VILLAGE OF VILLA PARK
Village Hall, Board Chambers
20 South Ardmore Avenue
Villa Park, IL 60181

Zoning Board Of Appeals (ZBA)

June 10, 2026

TO: Zoning Board of Appeals
FROM: Community & Economic Development Department
DATE: June 10, 2026
RE: **Petition ZBA-26-07 | 450 S. Villa Ave. | Variation**

EXISTING SURVEY WITH PROPOSED SITE PLAN OVERLAY
 SCALE : 1/8" = 1'-0"

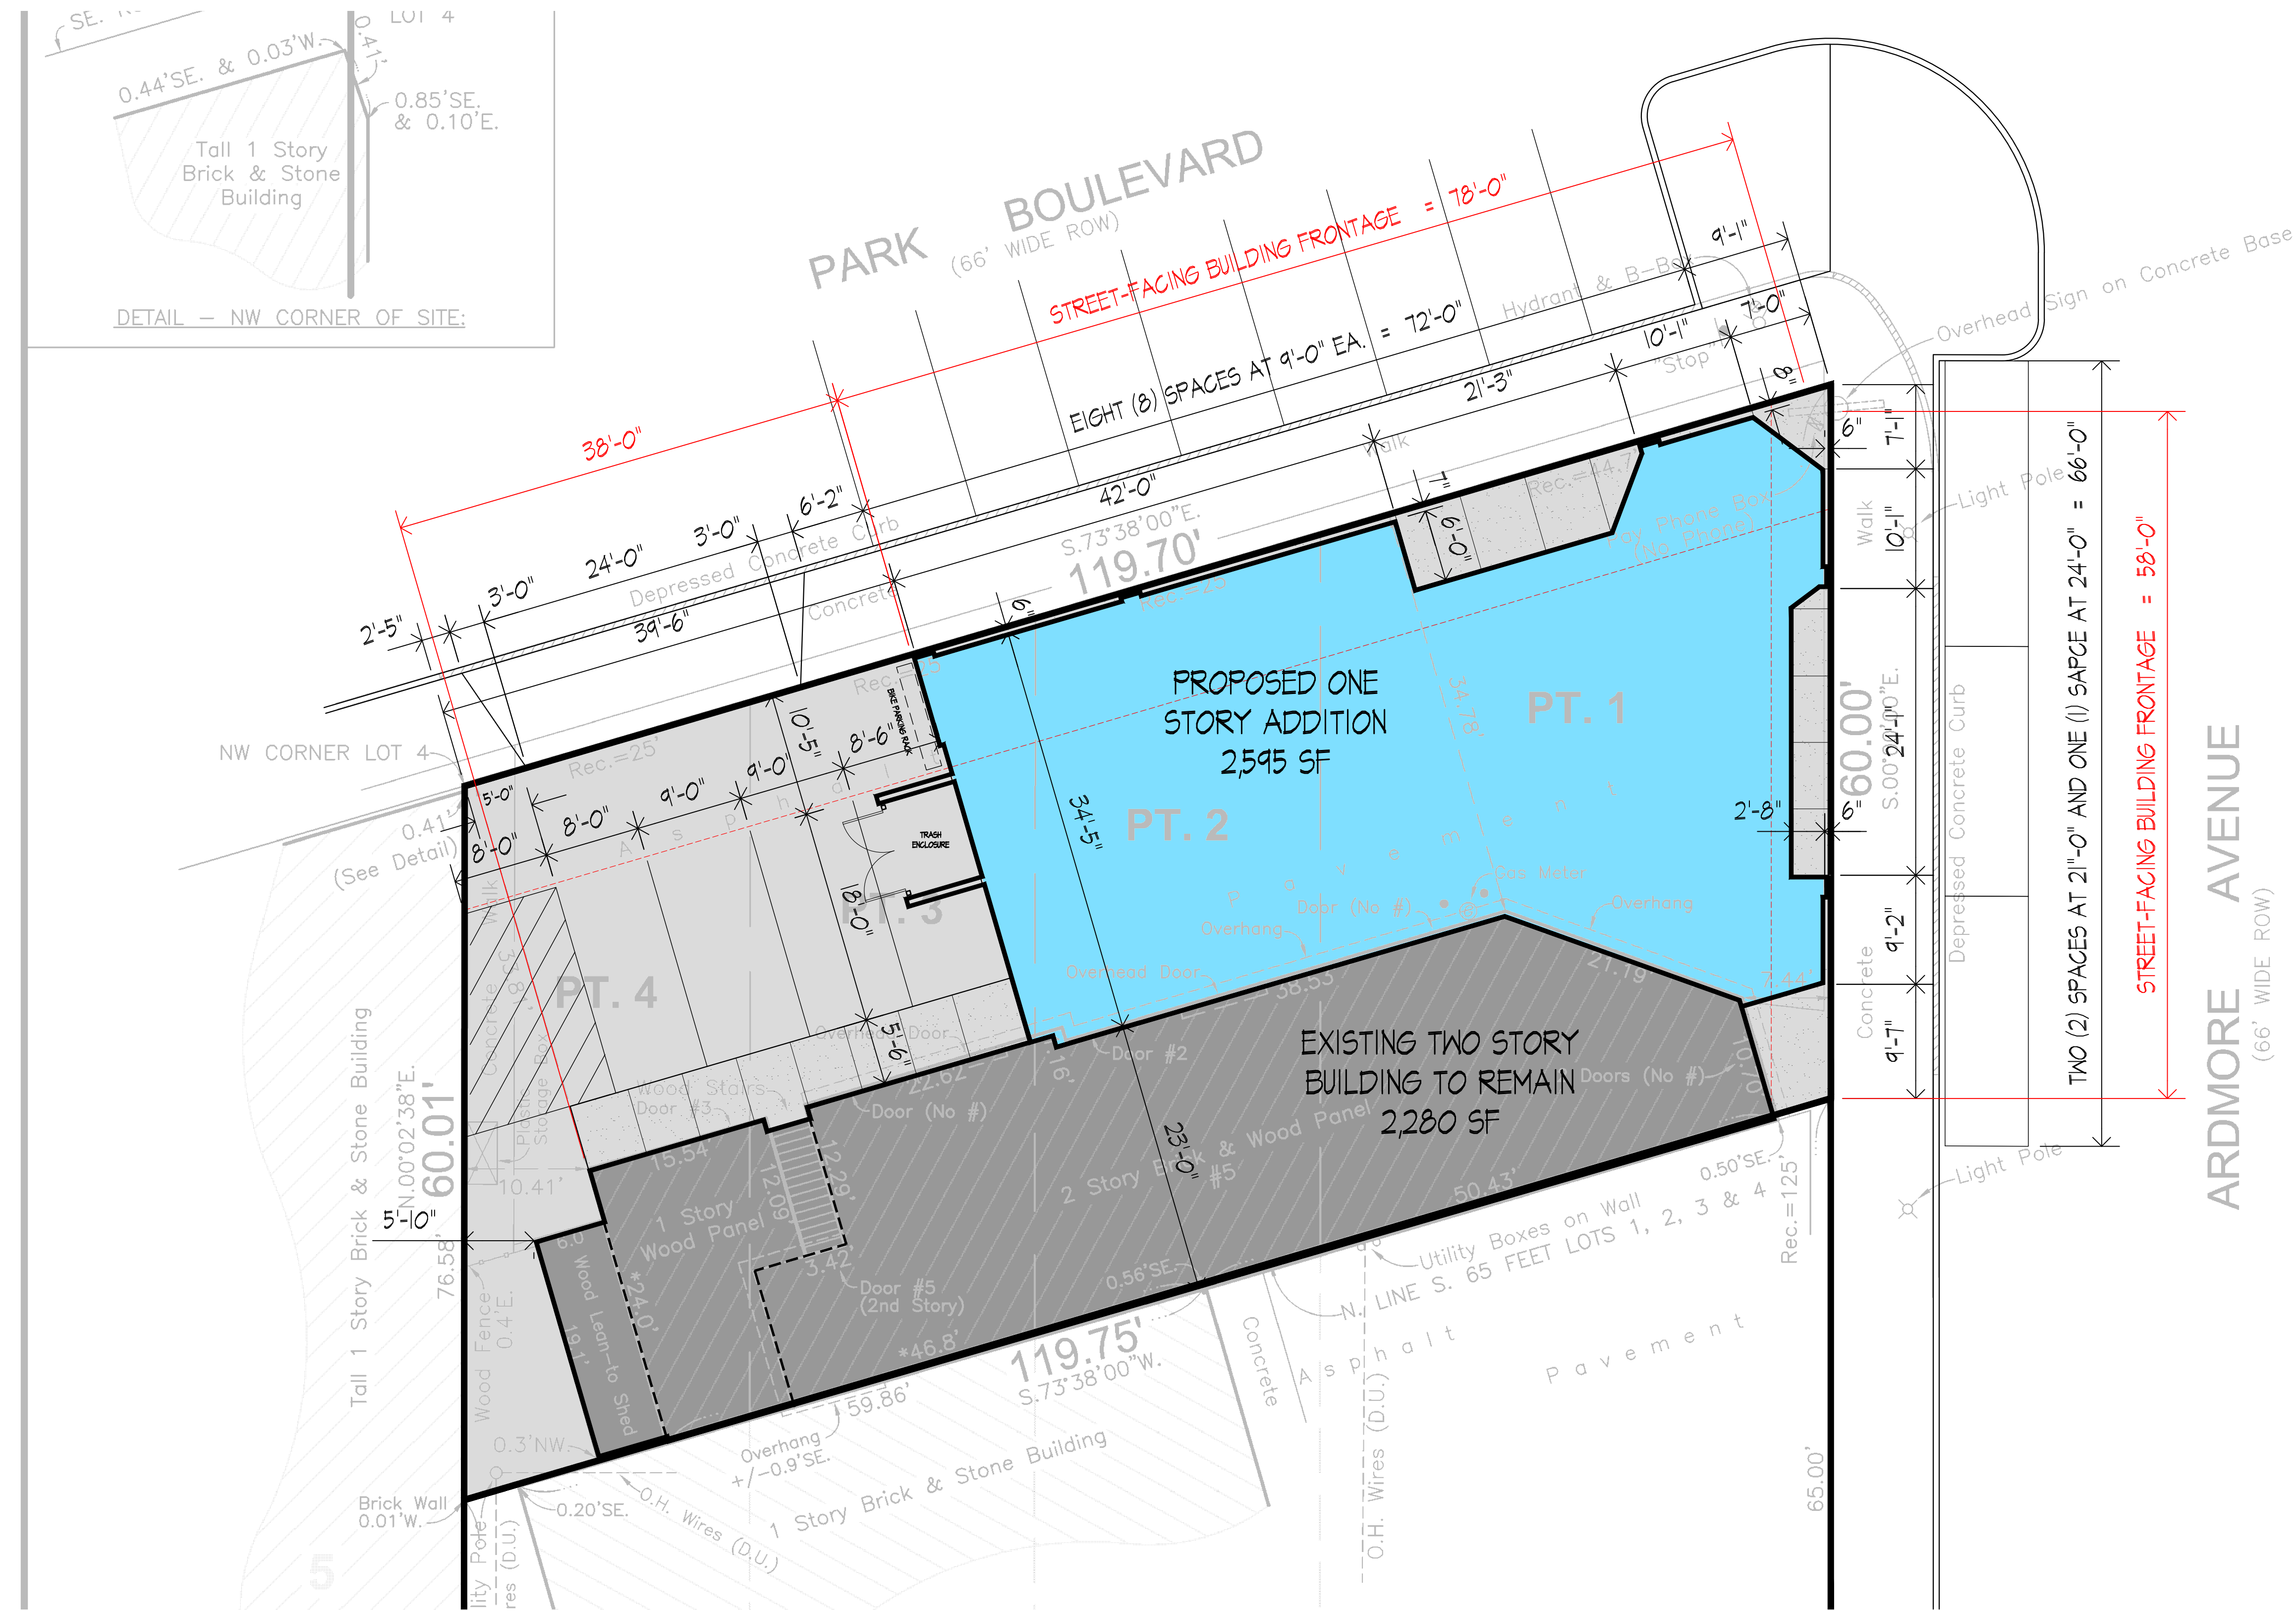
- a. Staff has noted areas where landscaping or planters could be added, but petitioner has declined these suggestions. Per Section 9.1.5.C, when a new development abuts non-residential properties, a landscaped buffer is required. While staff believe the landscape buffer is not practicable given site constraints and the scale and character of adjacent development. No landscaping is proposed as part of the Special Use application.
- b. Section 4.3.4 states that open space that is not used for sidewalk or patio space, shall contain landscaping. Staff has suggested two areas where landscaping could be installed. Staff has also suggested planter boxes be installed to include some type of vegetation. ***The petitioner has declined these suggestions and should speak to their decision to omit landscaping.***

Staff has concerns regarding the potential for low light levels in the parking lot in the evening when the restaurant and bar will be active (compared to the salon at the subject property). ***In response to these comments, the petitioner indicated a willingness to install lighting in the parking area and that has been included as a condition of approval.*** The petitioner has agreed to provide a photometric plan as part of the permitting process if requested by Staff.

- 4) *Prior to filing any Building Permit Application, the petitioner shall provide the Village with a Landscape Plan identifying areas for open lot landscaping and plantings consistent with discussion with the Zoning Board of Appeals, as determined by the Director of Community and Economic Development and Chairperson of the Zoning Board of Appeals. If such designs are deemed to be inconsistent with the direction provided by the Zoning Board of Appeals, then the petitioner will be required to file an application for an amendment to the Special Use Permit.*

- 7) *Prior to filing any Building Permit Application, the petitioner shall provide the Village a Lighting Plan that includes lighting for the parking lot for review and approval by the Director of Community and Economic Development and Chairperson of the Zoning Board of Appeals. If such designs are deemed to be inconsistent with the direction provided by the Zoning Board of Appeals, then the petitioner will be required to file an application for an amendment to the Special Use Permit.*

PROPOSED EAST ELEVATION (ARDMORE AVENUE)

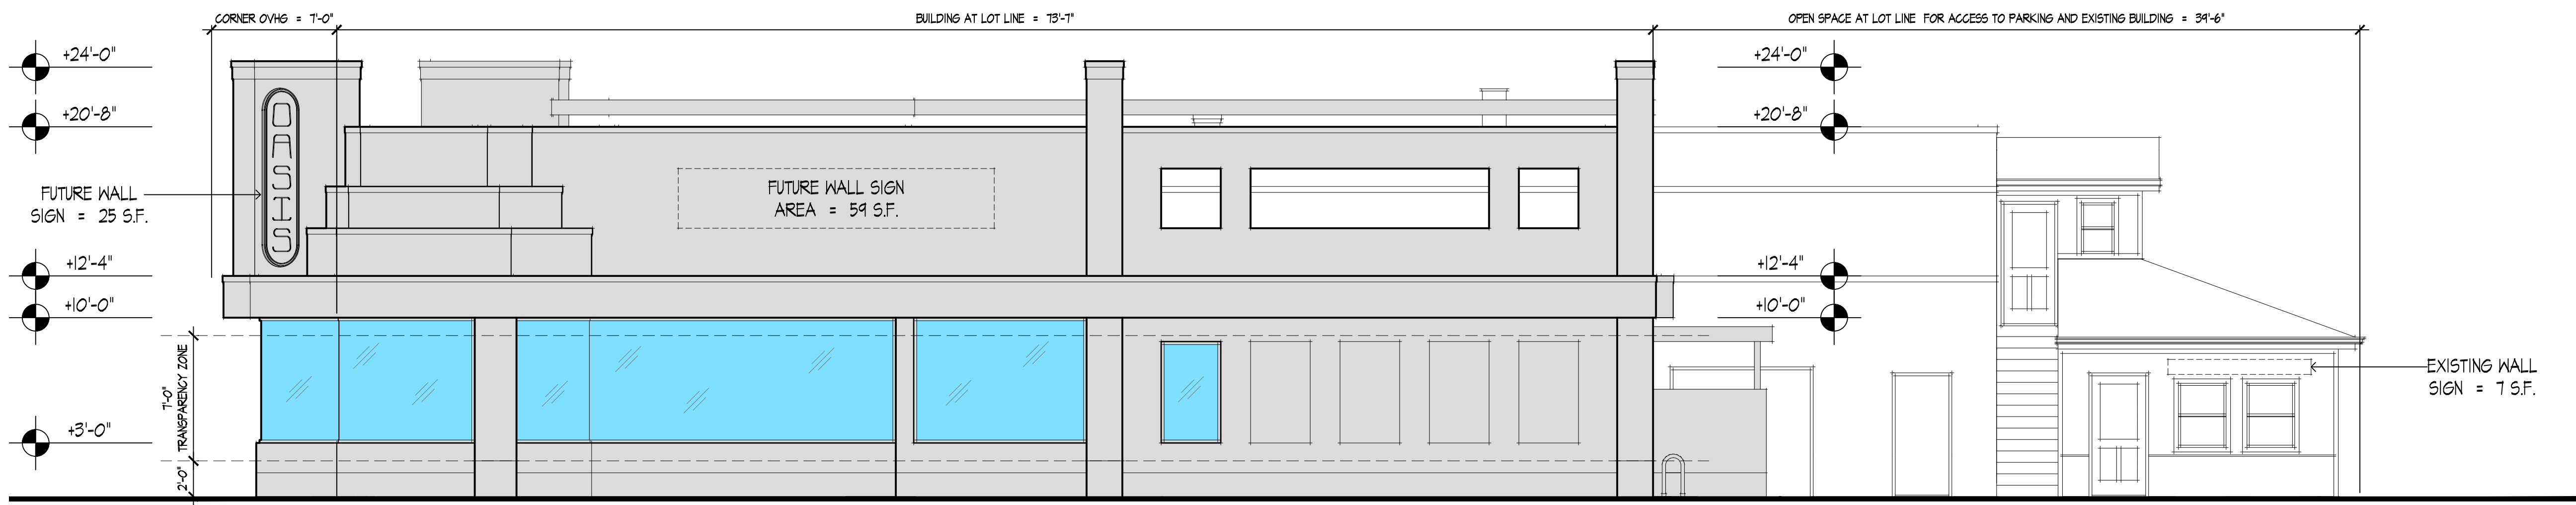
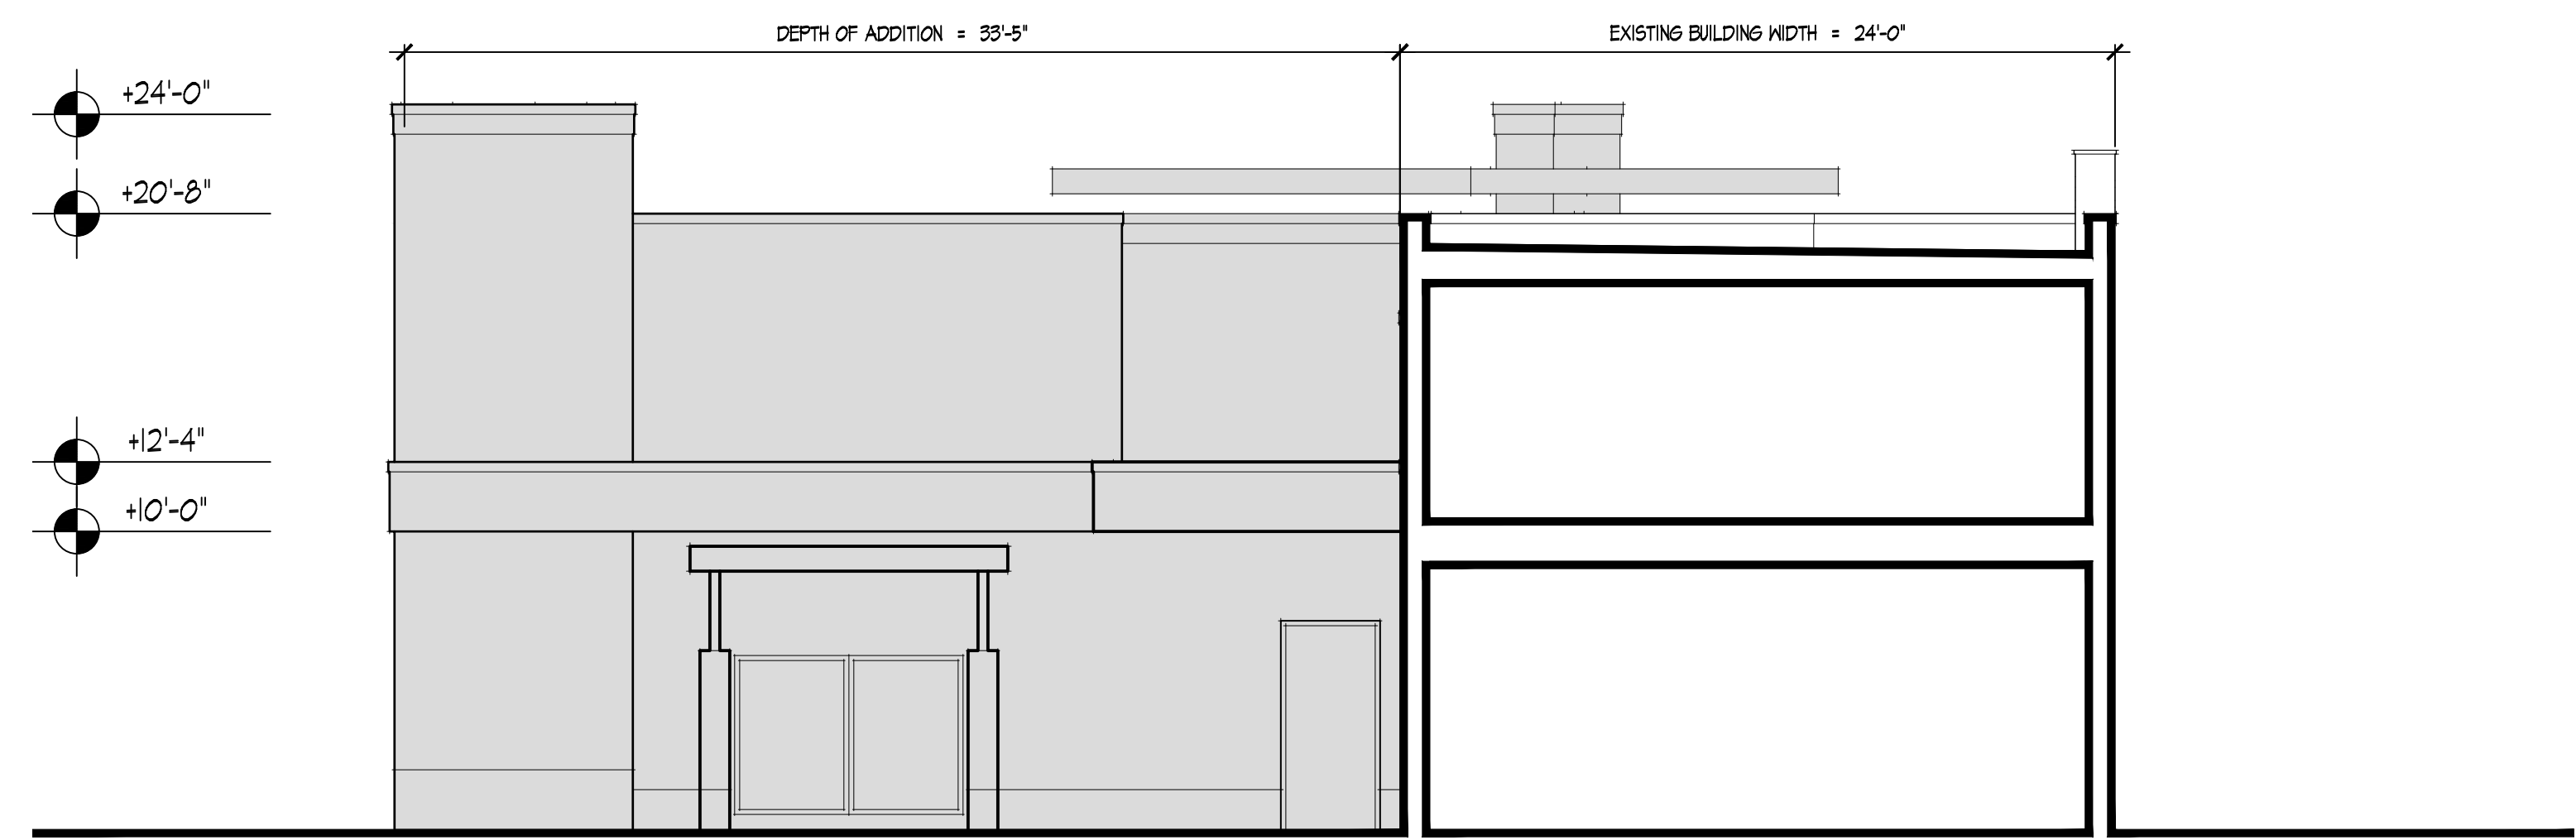
Per section 4.7.1, 80% of each façade shall be constructed of primary materials. Permitted primary building materials include high quality, durable, natural materials, such as stone, brick; wood lap siding; fiber cement board lapped, shingled, or panel siding; glass. Other high quality synthetic materials may be approved during the site plan process with an approved sample and examples of successful, high quality local installations. While architectural panels are commonly used as accent materials, Staff has concerns regarding the use such panels as a primary material.

Per section 4.7.1, main building colors shall utilize any historic palettes from any major paint manufacturer. Other colors may be utilized for details and accents, not to exceed a total area larger than ten (10) percent of the facade surface area. The petitioner did not provide an indication as to which colors are proposed and Staff was unable to determine with compliance as a result. ***Staff recommends that compliance with building color requirements be included as a condition of approval.***

- 6) *Prior to filing any Building Permit Application, the petitioner shall provide the Village with final elevations and material specifications for review and approval. Final elevations and materials must be deemed consistent with the approved elevations and materials, as determined by the Director of Community and Economic Development and Chairperson of the Zoning Board of Appeals. If such designs are deemed to be inconsistent with the approved plans or if materials are deemed to be of a lower quality than the approved materials, then the petitioner will be required to file an application for an amendment to the Special Use Permit.*
